THE VILLAGES AT STERLING RANCH PUD DEVELOPMENT PLAN / PRELIMINARY PLAN

LETTER OF INTENT

NOVEMBER 2024

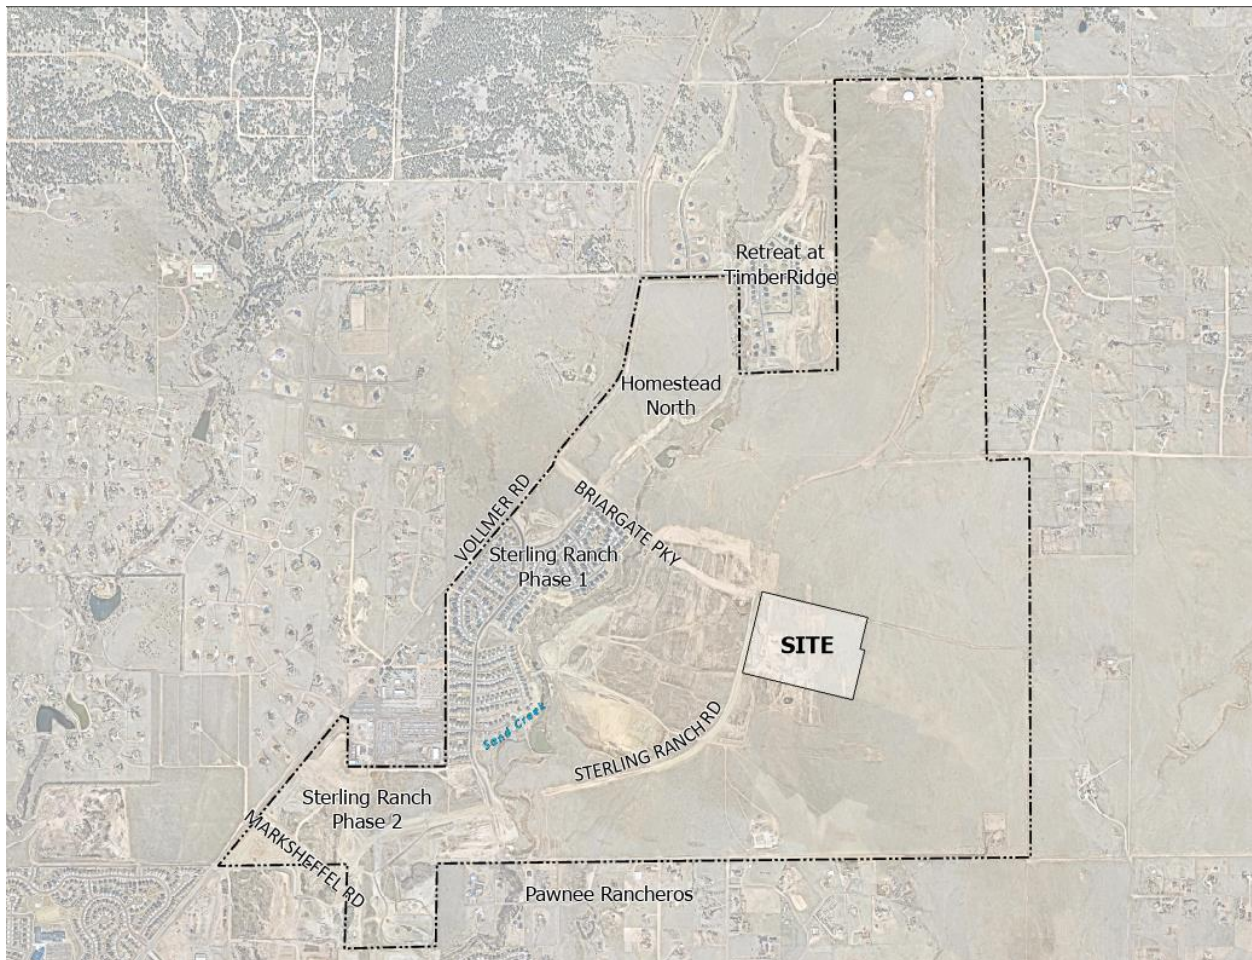
Does not add up to 227. If the 38 units with an option for an ADU are part of the 173 units, please clarify that.

As written in Prelim Plan
